Subject: Project name _____
Project site address 11001 Guildford Road Annapolis Junction
Permit # B21000847 SDP # _____
Other information pertinent to this project _____

Amendment, Permit # B 21000847

WOOD RAMP CHANGES TO CONCRETE RAMP
1ST FLOOR FRAMING TO CLOSE STAIR OPENING

This is a permit revision or Amendment to Building Permit#B21000847
approved Drawings:

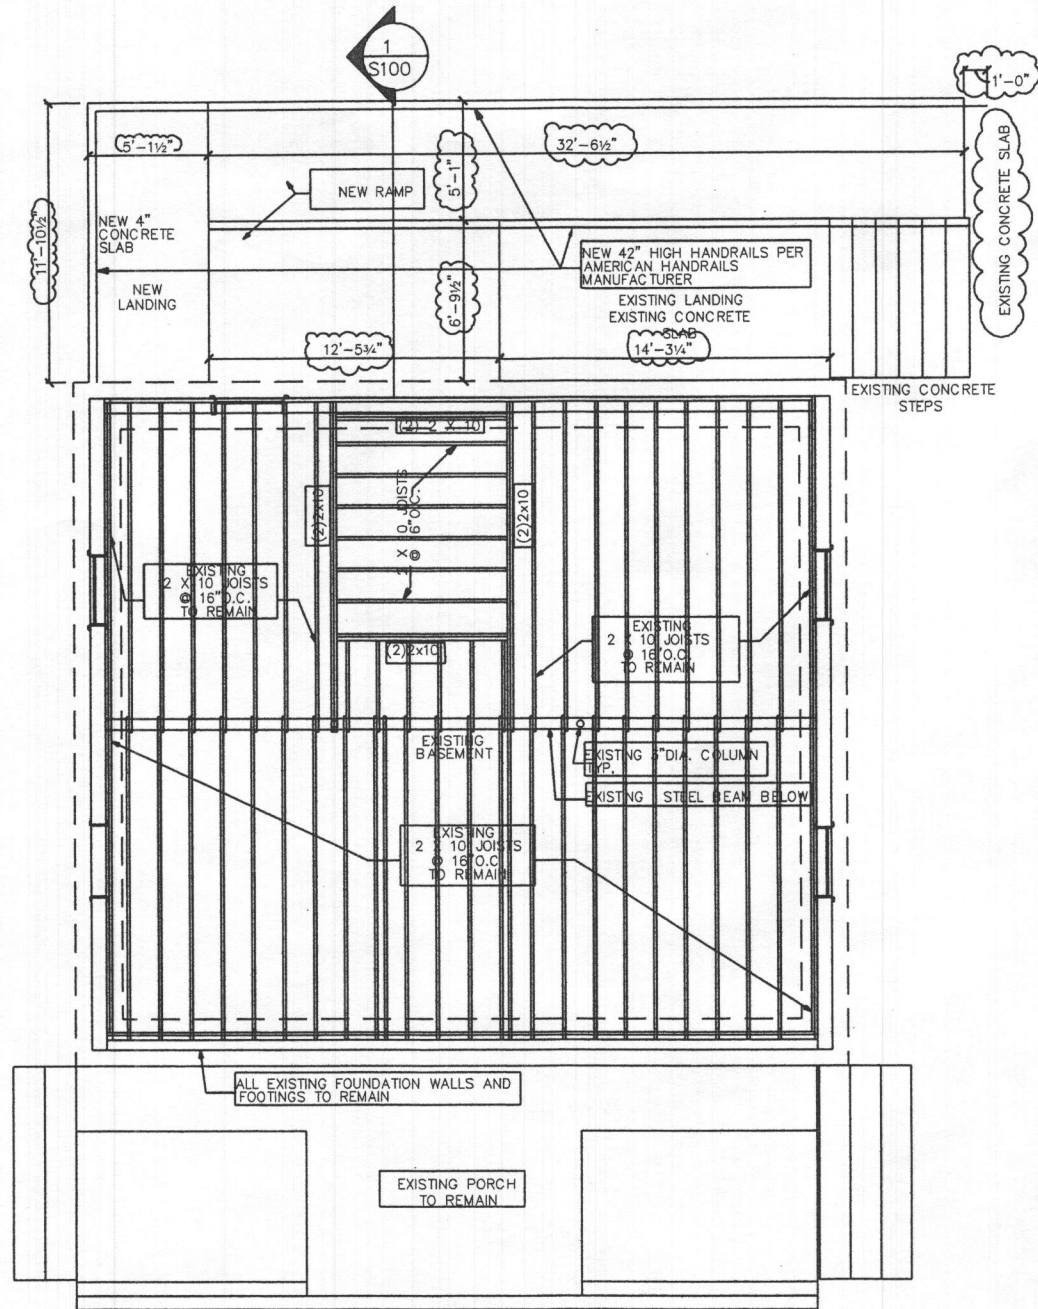
A200-CONCRETE RAMP ELEVATION
S100-1ST FLOOR FRAMING PLAN & DETAIL
S200-JOIST & RAMP SECTION VIEW
